Product Change Notification: E-21-003453

PCN Date: 06-APR-21

DEUTSCH DT 4,6,8,12-Way Plug and Receptacle Housing Change and Add Second Manufacturing Location

Logo and Text

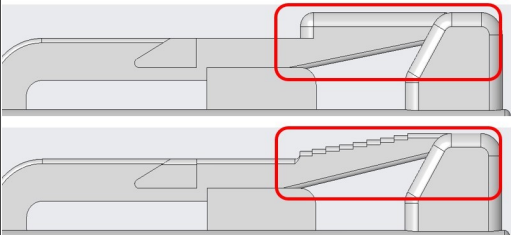
TE-ICT is releasing new capacity tools and making slight form changes to DT 4,6,8,12-Way plug and receptacle housing part numbers, listed below. Changes include: Plug front seals will use seal retention version, logo and part number text, latch ends, and rounded edges. See pictures below and attached presentation for details, 4 and 12-way shown as an example. Also, as part of this initiative, TE-ICT is adding a second manufacturing location in China. CN will be added for those PNs manufactured in China to indicate the country of origin. These PNs are TE proprietary designs, therefore considered catalog/general market product. PPAP and/or sample requests must be submitted via ict-ppap-request@te.com or ePPAP system. PPAPs will be completed by part family and will be available upon request only. All PPAP requests must be received within 14 days of receipt of this notification. Product drawings are affected and will be updated as the changes are phased in.

DEUTSCH Logo and text

TE Logo and text

Latch Design

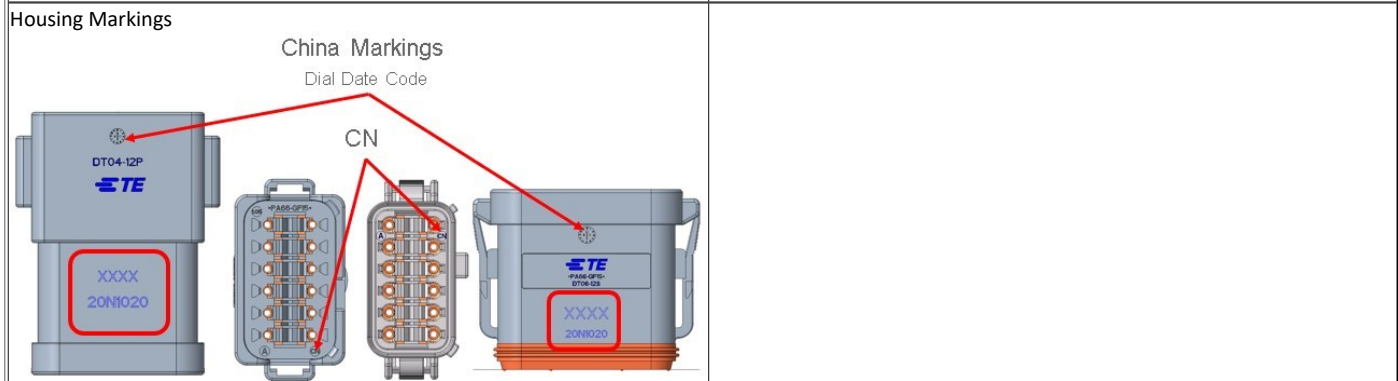
Current Latch Design

New Latch Design

Rounds

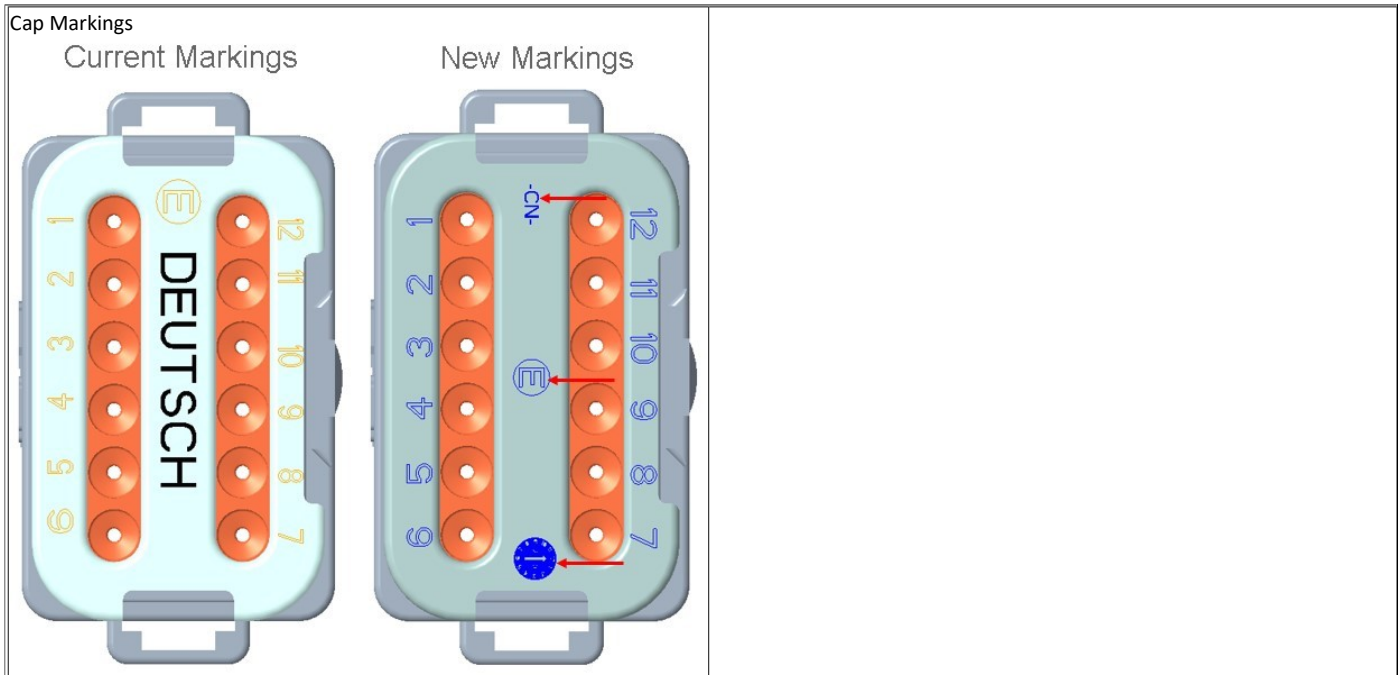
Current Design

New Design with added rounds
